ERRATA SHEET FOR:

Derivation of a Site-Specific Water Column Selenium Standard for Lake Kooconusa, MT

Page 20: Figure 2-9 should be replaced with:

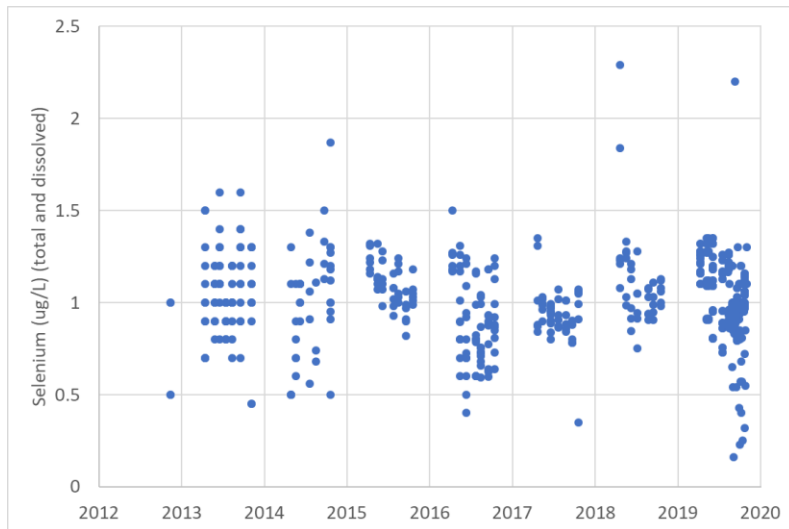
Page 20: Figure 2-9 caption, sentence one — “USEPA Region VIII, personal communication, 7/10/2020” should be updated to read “USEPA Region VIII, personal communication, 9/22/2020”
